**TOWN OF OCEAN RIDGE
PLANNING & ZONING REGULAR MEETING
AGENDA**

To: Planning & Zoning Board Members
From: **Corey O’Gorman, Town Planner**
Meeting Date: September 17, 2024
Subject: 5920 N Ocean Blvd – Development Plan Review

PLAN REVIEW REPORT
5920 N Ocean Blvd
REV 5 - Summary

PLAN REVIEW REPORT
5920 N Ocean Blvd
10/16/2023 REV 1

SHEET NUMBER: **A-0.2**

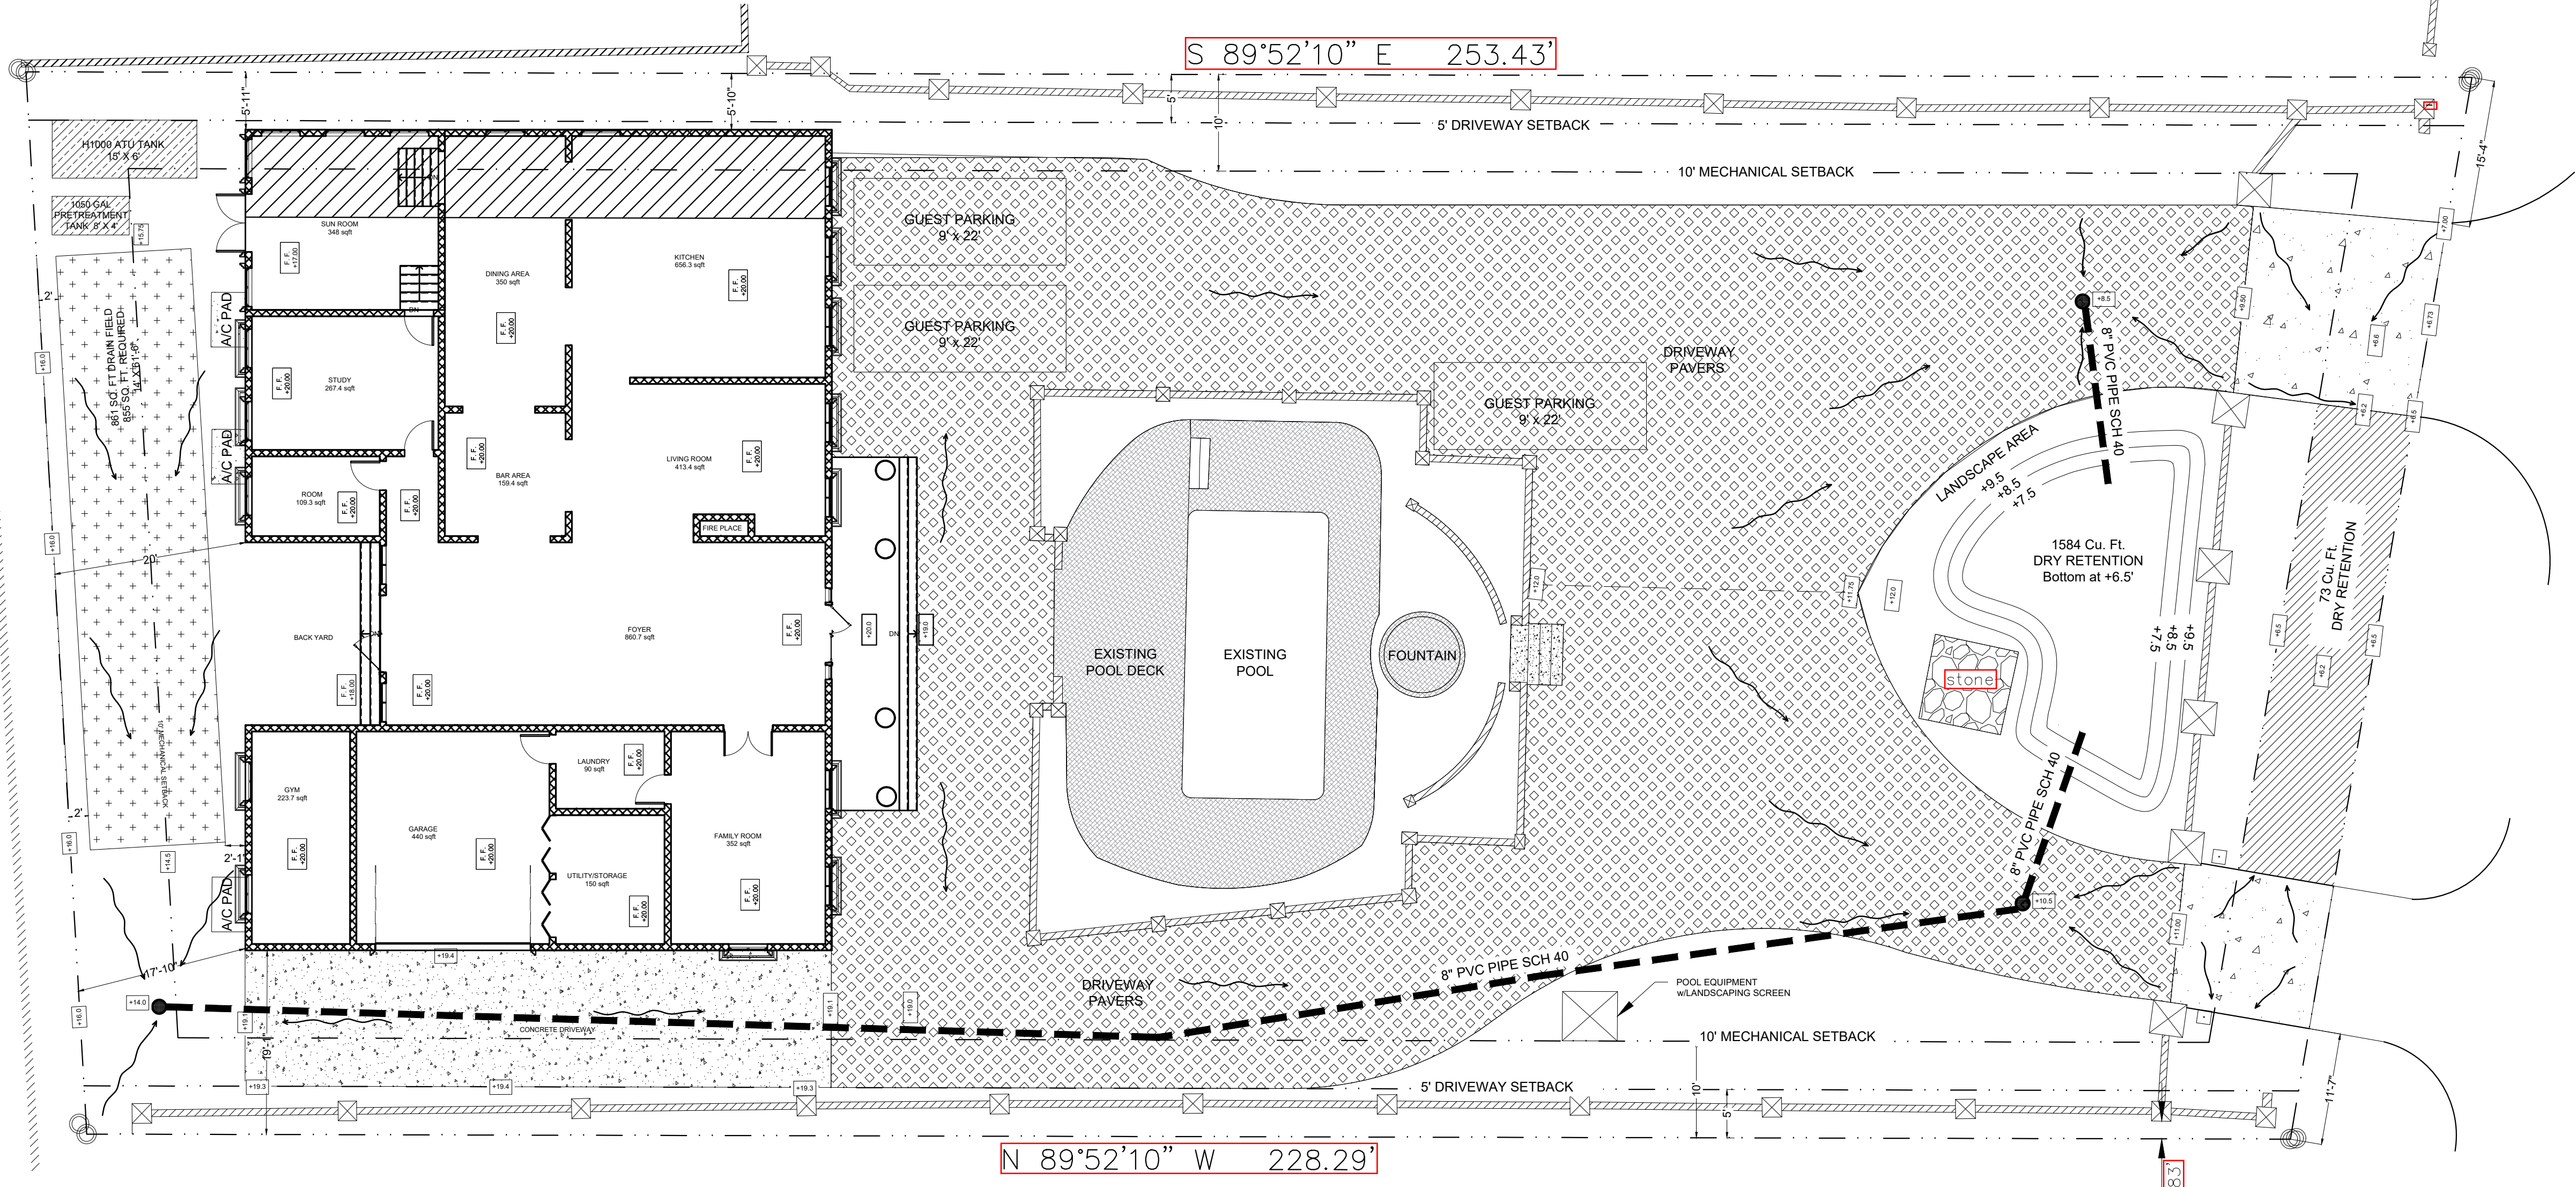
~~Comment: Sheet A-0.2 shows two driveway accesses to N Ocean Blvd, but does not show a dimensioned setback. Please revise the site plan to show the correct setback. This comment is addressed.~~

~~Comment: Sheet A-0.2 shows a reconfigured driveway area near the pool and new driveway access to the garage, but does not show the required 5' setback. Please revise the plan to show the required 5' setback. This comment is addressed by the revised plan Sheet A-0.2.~~

SHEET TITLE: Drainage & Septic Plan
 SHEET NUMBER: A-0.3

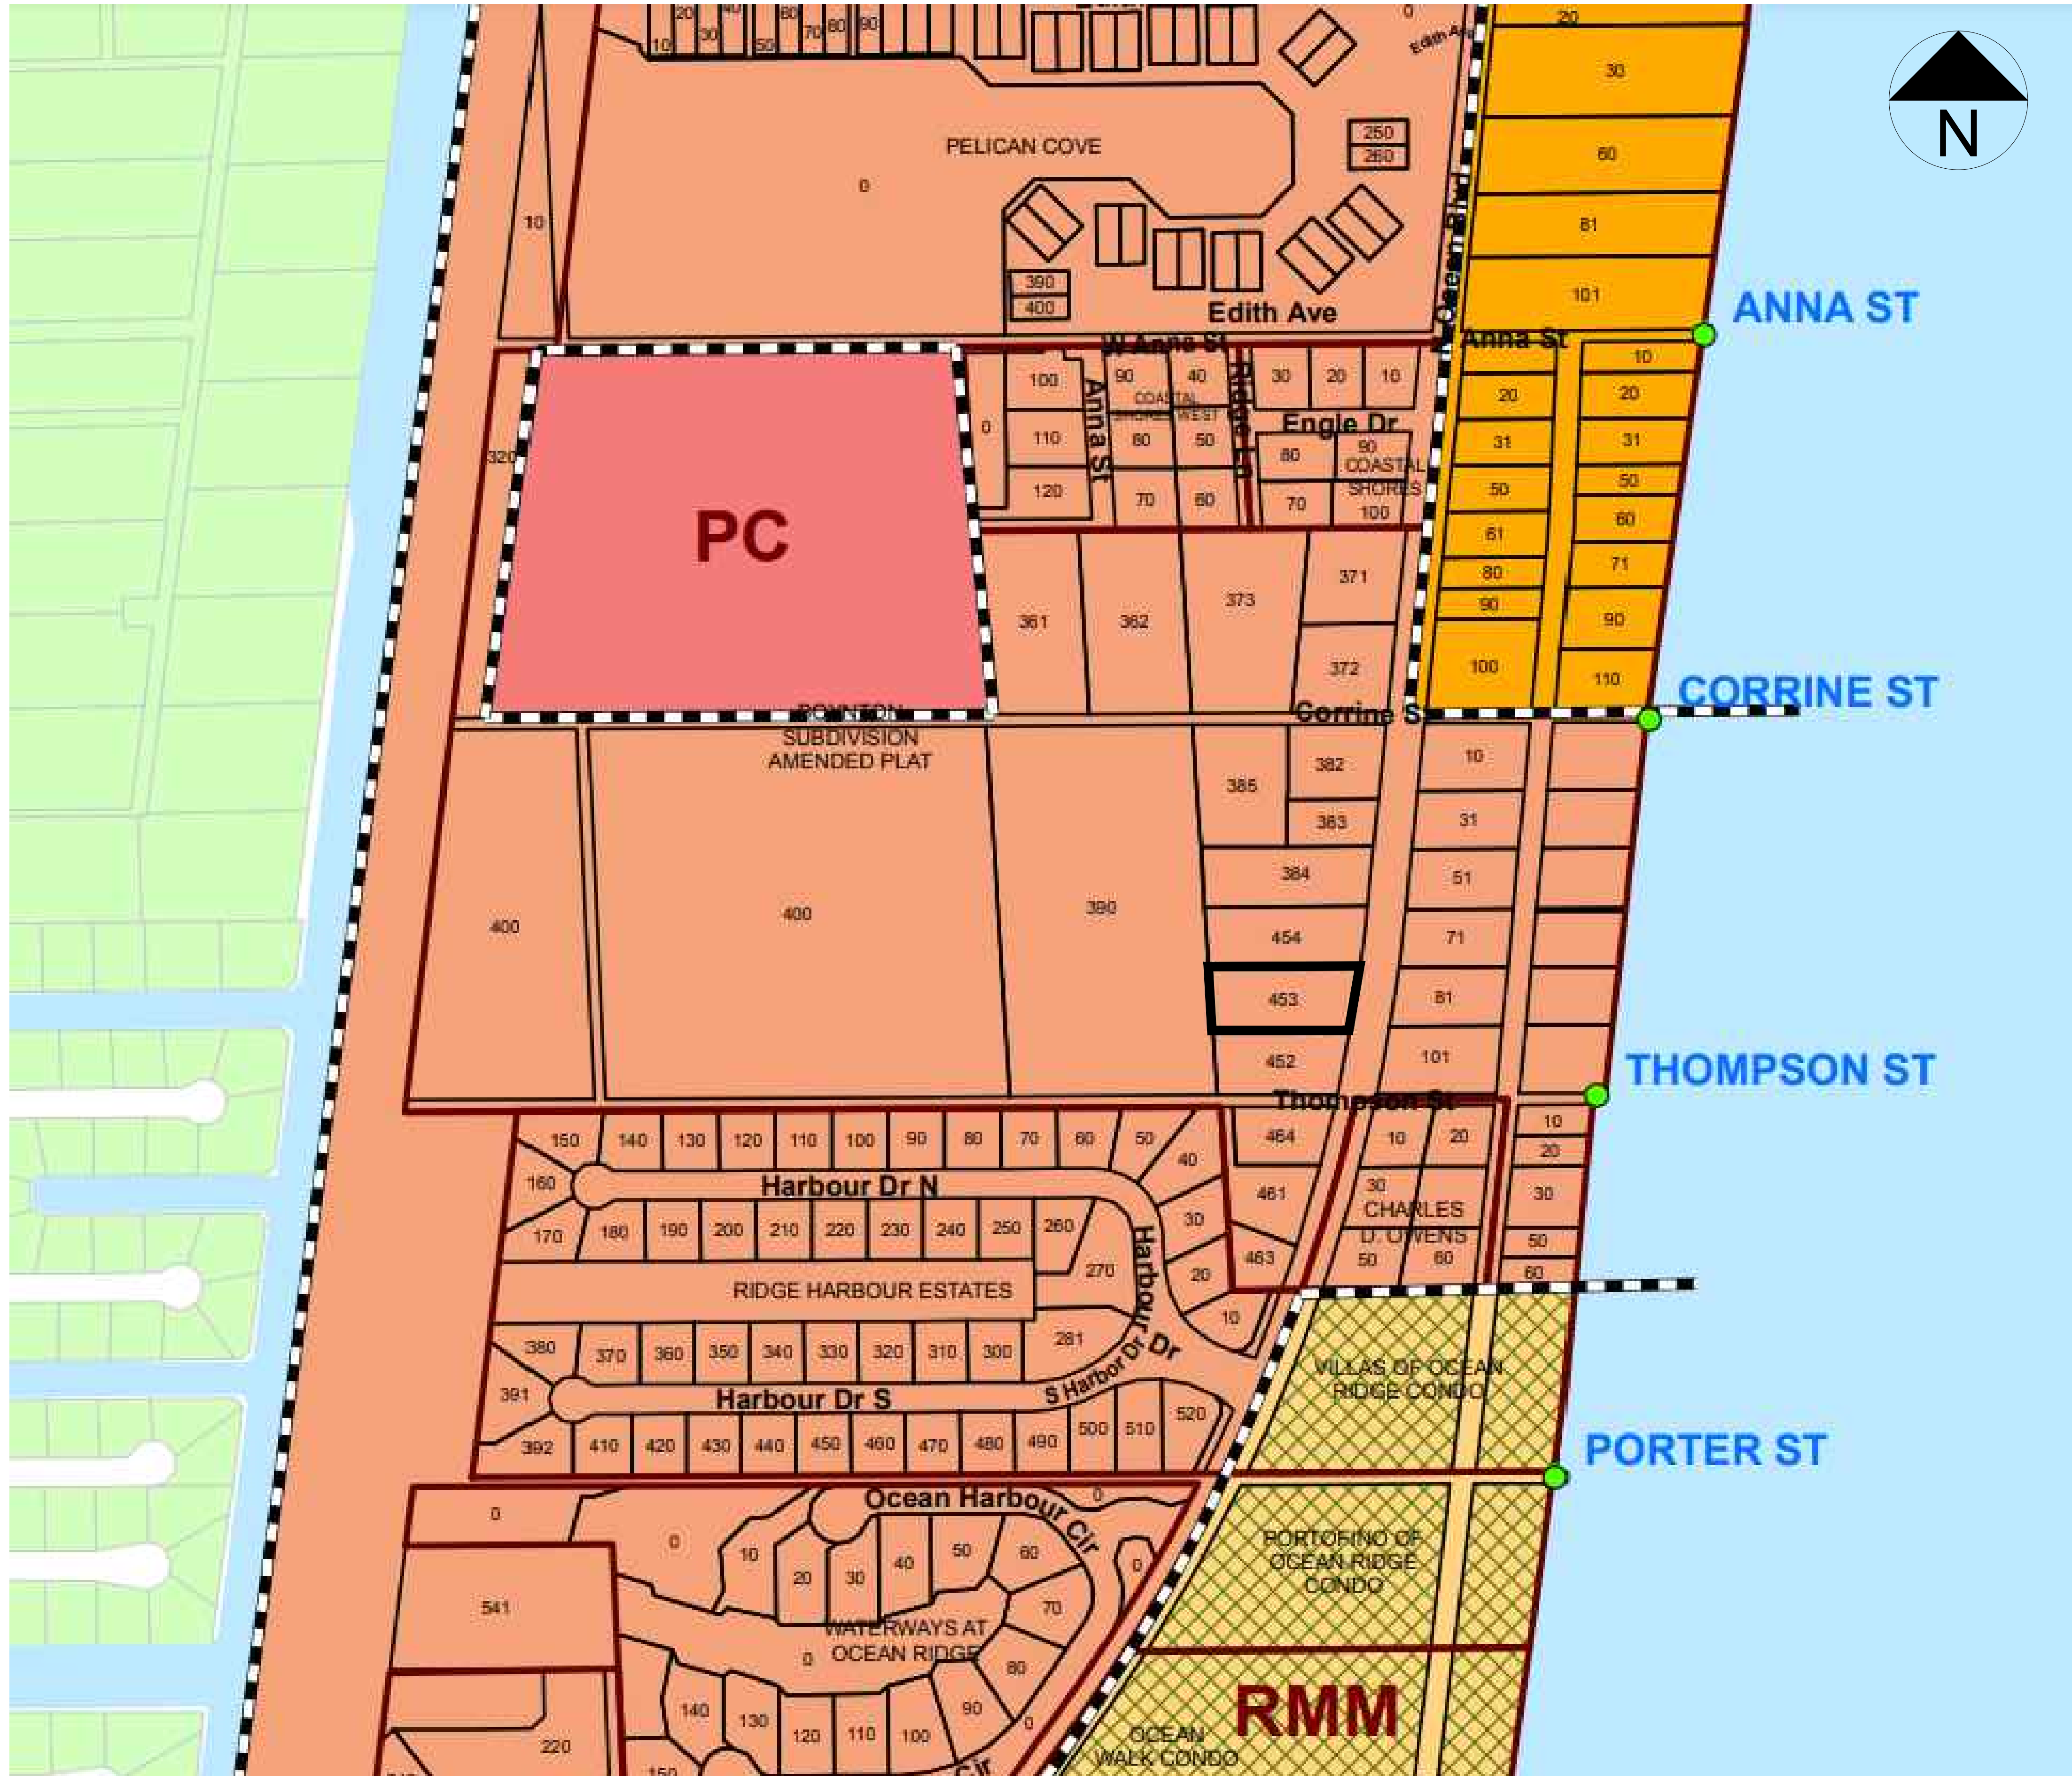
REV 4: The drainage and septic tank sheet A-0.3 shows both the AC condensing units and the pool equipment. There is a note for the pool equipment that it will be screened with landscaping, but neither the AC or pool equipment are shown on the site plan sheet A-0.1 or landscape plan sheet A-0.2. Please revise all three sheets to show the AC and pool equipment, and show them all screened on the landscape sheet A-0.2 as required by the code. THIS COMMENT IS ADDRESSED TO SHOW ALL MECHANICAL EQUIPMENT BUT DOES NOT SHOW SCREENING. A CONDITION OF APPROVAL IS THAT ALL MECHANICAL EQUIPMENT MUST BE SCREENED IN ACCORDANCE WITH TOWN CODE.
